# UCL Bicentennial Projects: Main Quad

Planning & Listed Building Consent Document: Revised Trees Addendum

1014 | Revision A | 28th February 2025

Burwell Architects

# 3.0 Proposed Amended Layout

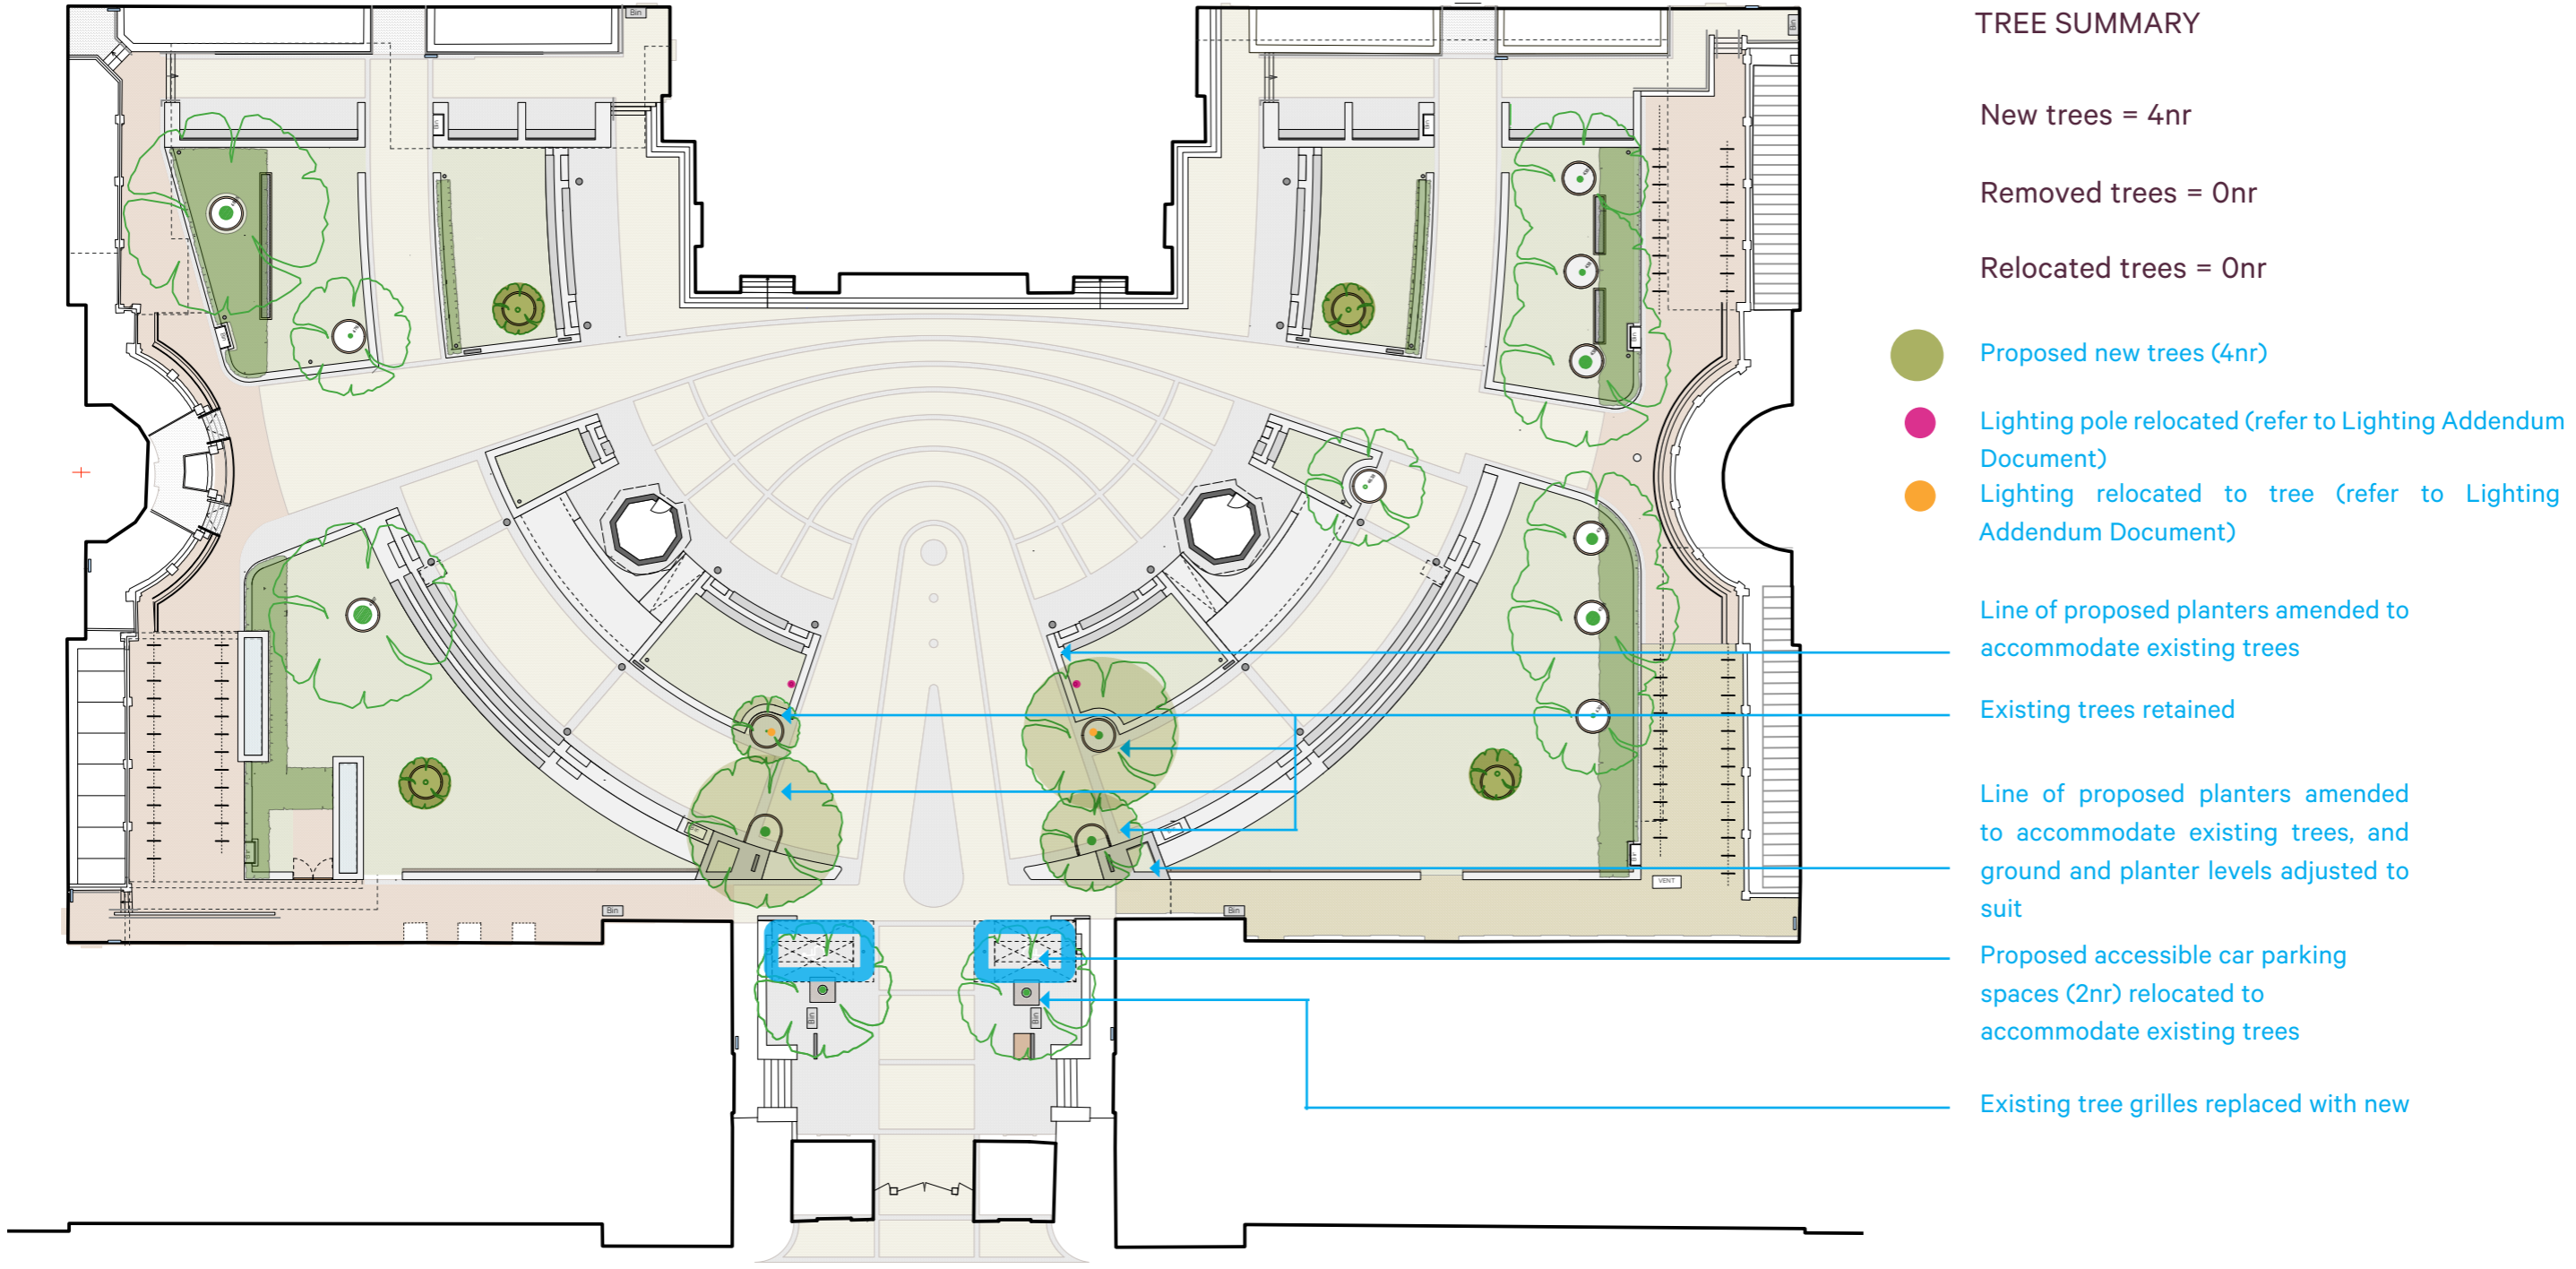
The below layout highlights the proposed amendments to the scheme.

- Proposed new trees (4nr)
- Lighting pole relocated (refer to Lighting Addendum Document)
- Lighting relocated to tree (refer to Lighting Addendum Document)

Line of proposed planters amended to accommodate existing trees

Existing trees retained

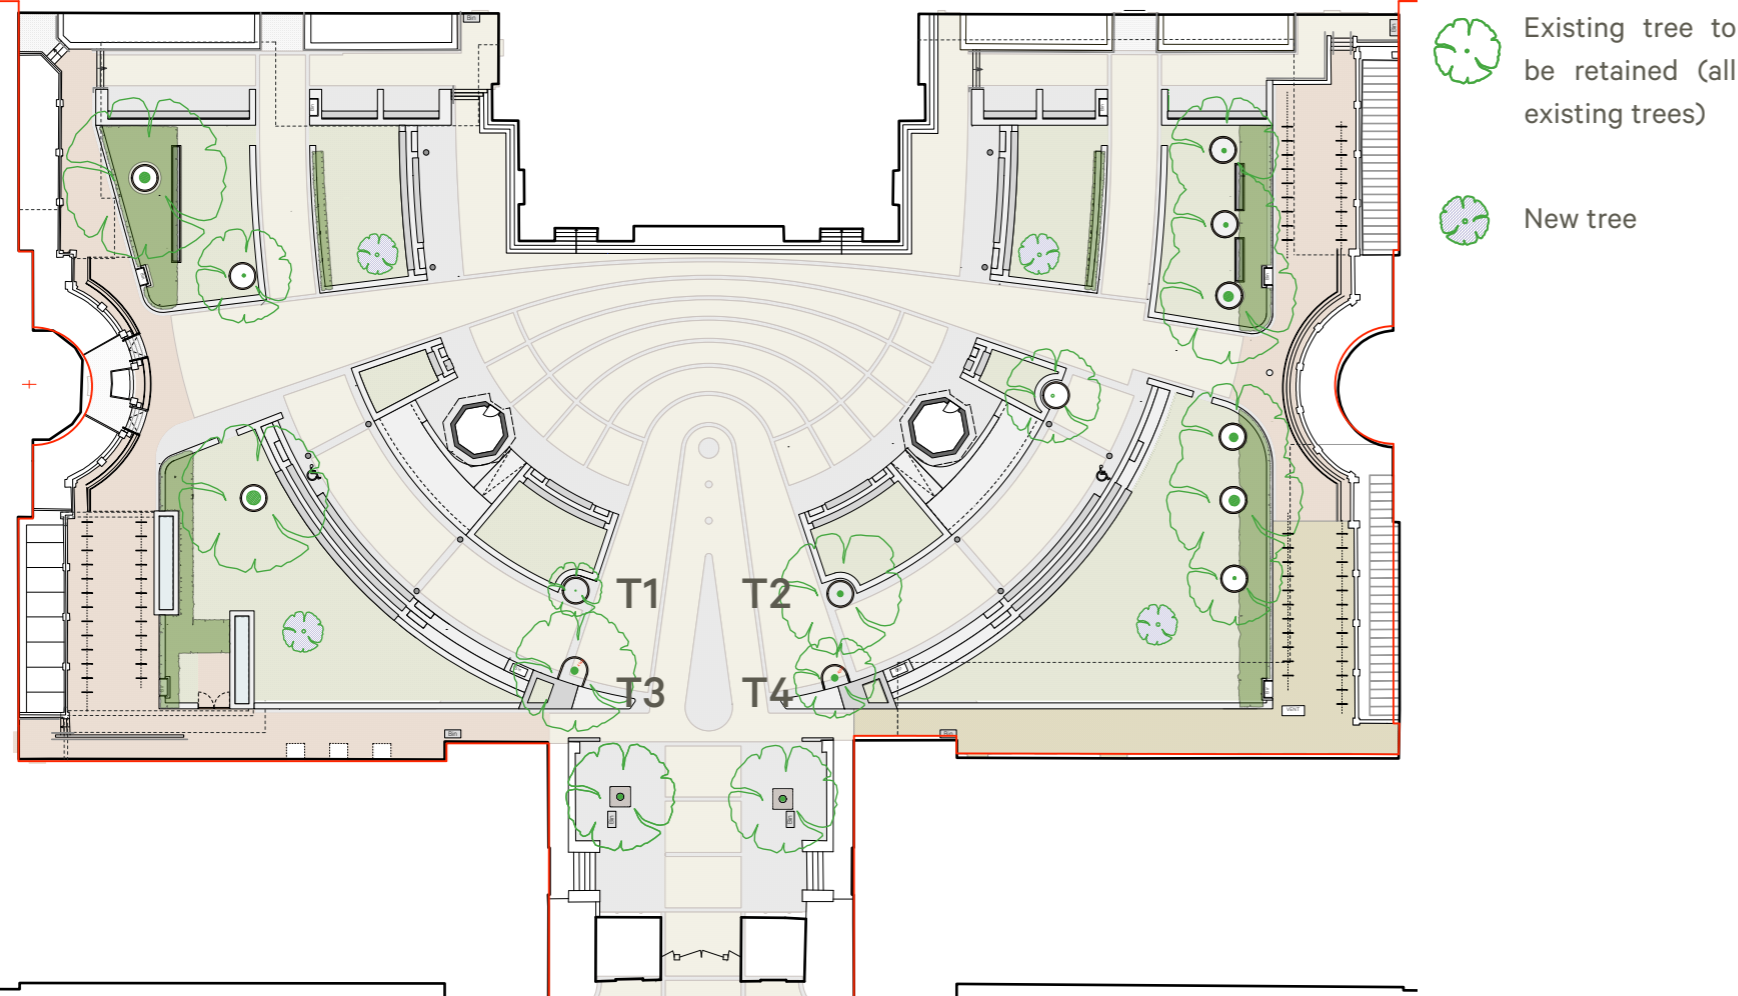
Line of proposed planters amended to accommodate existing trees, and ground and planter levels adjusted to suit

Proposed accessible car parking spaces (2nr) relocated to accommodate existing trees

Existing tree grilles replaced with new

Detailed Layout Showing Accessible Car Parking Space

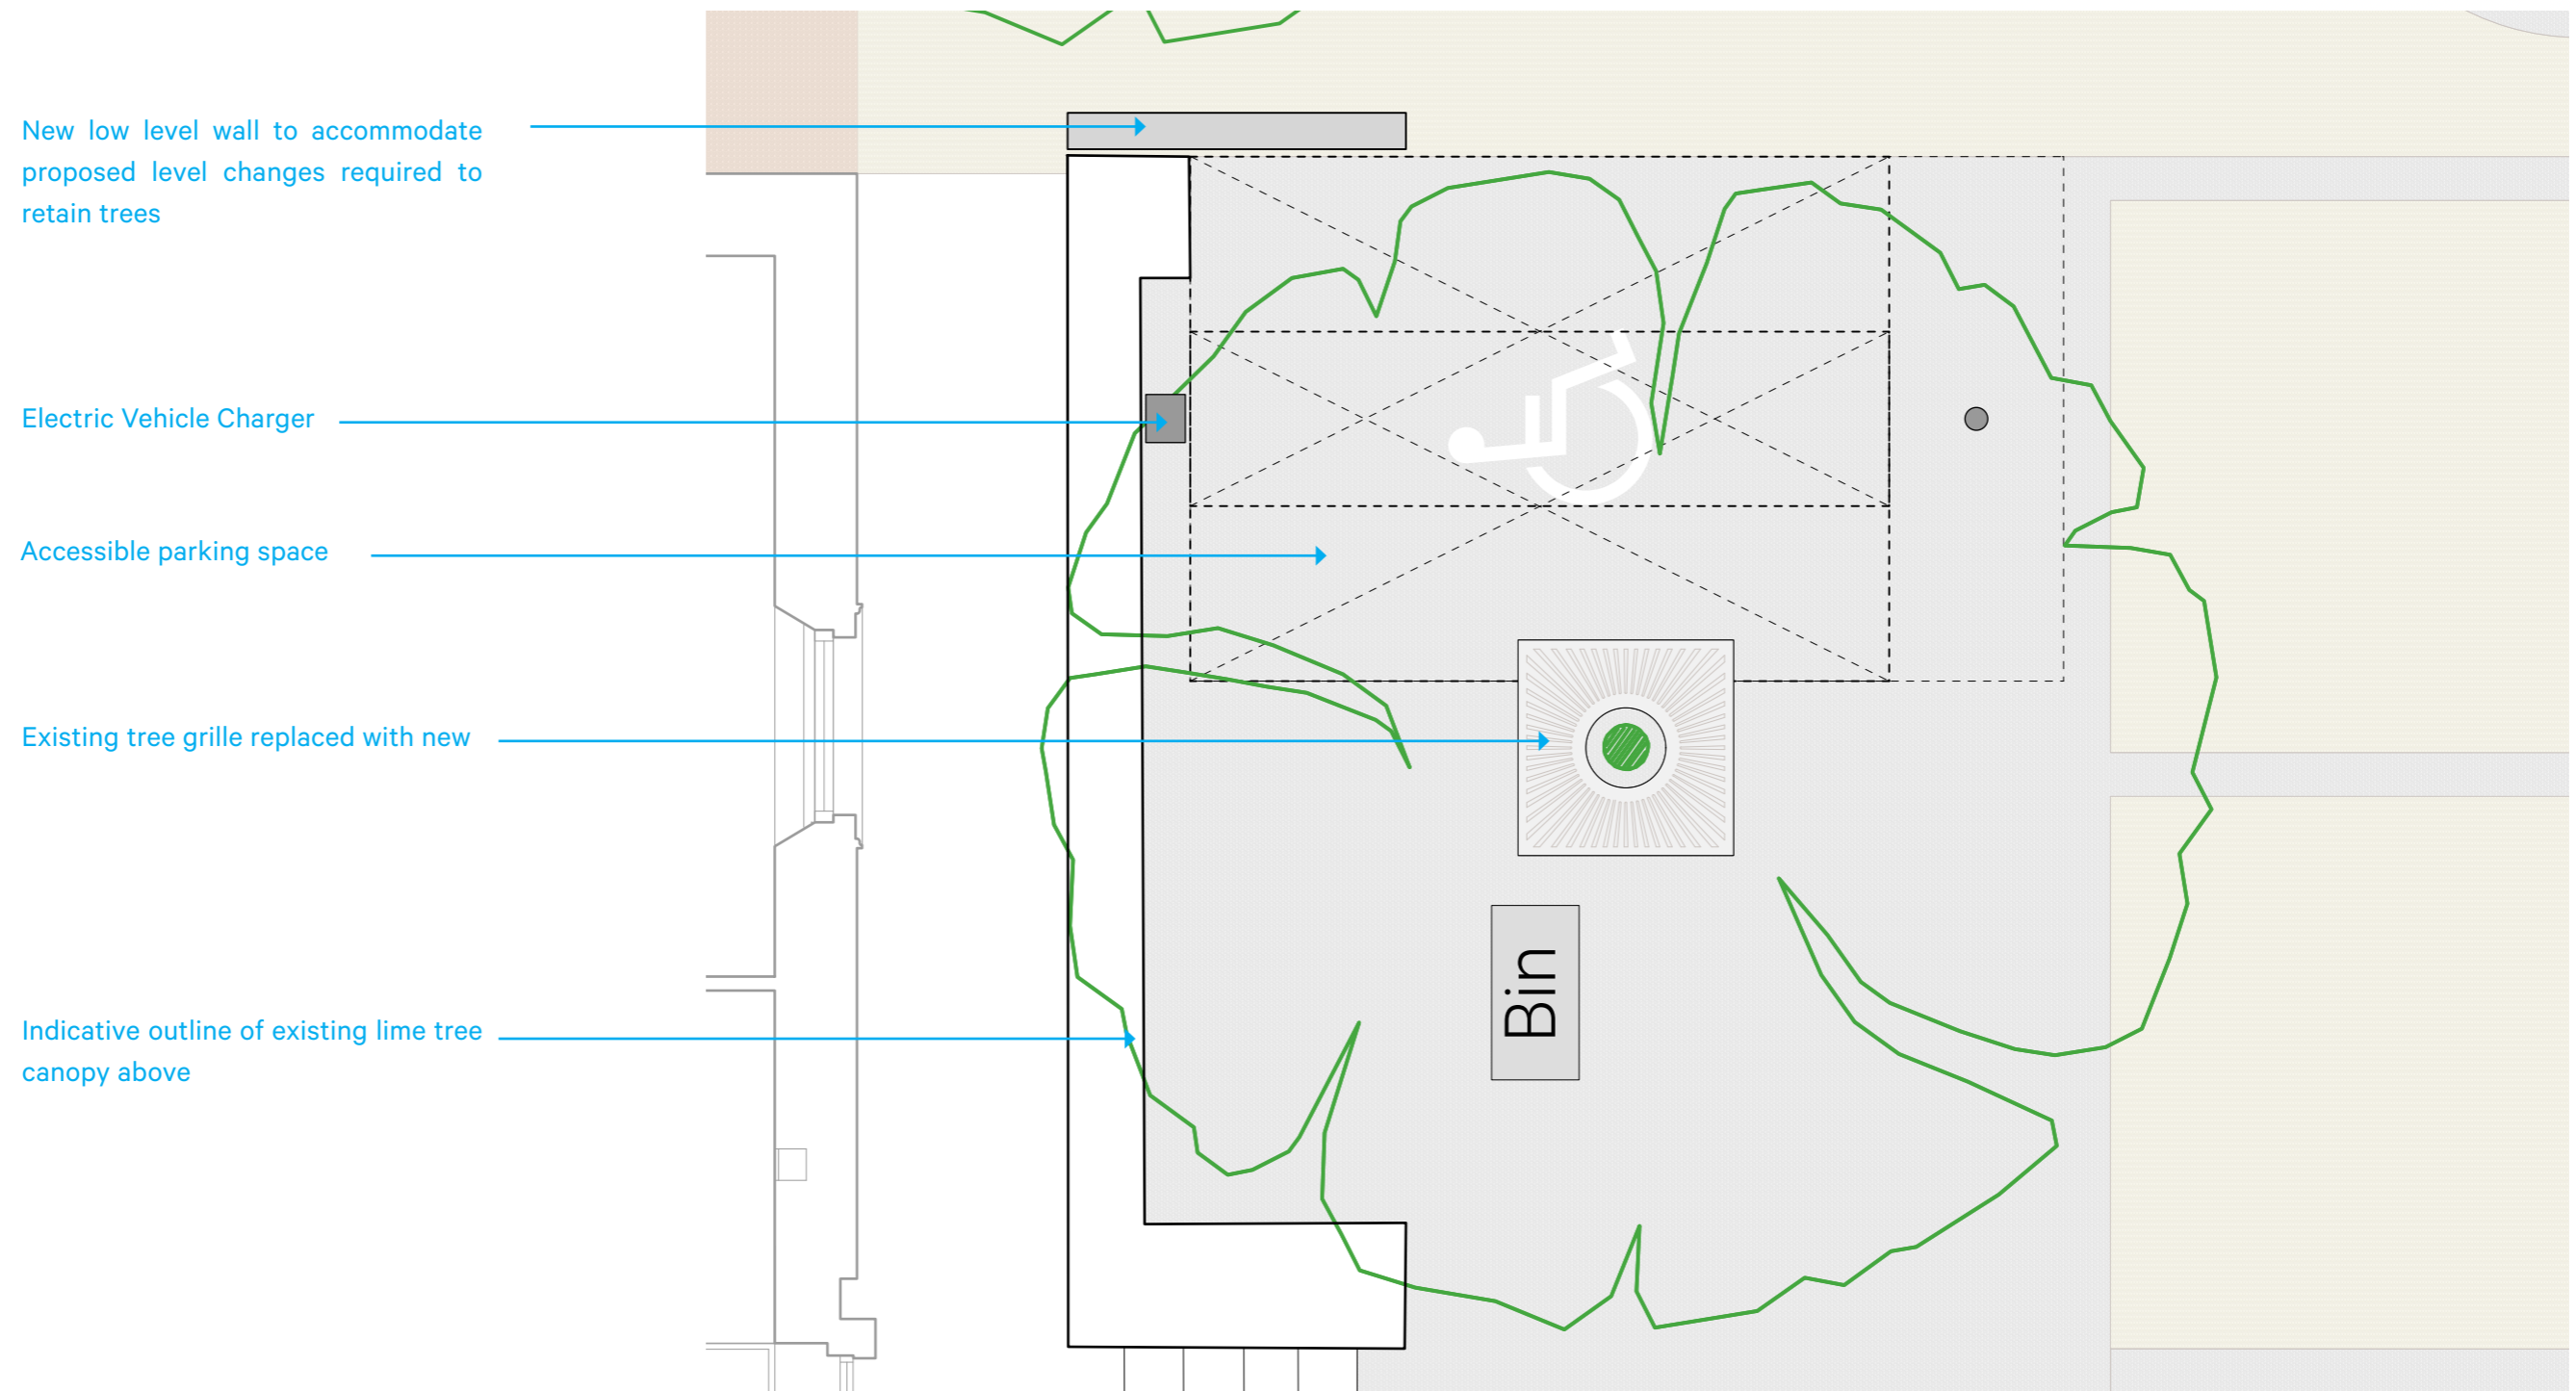
The below detailed layout shows the revised accessible car parking arrangement (for the parking space on the north of the entrance).
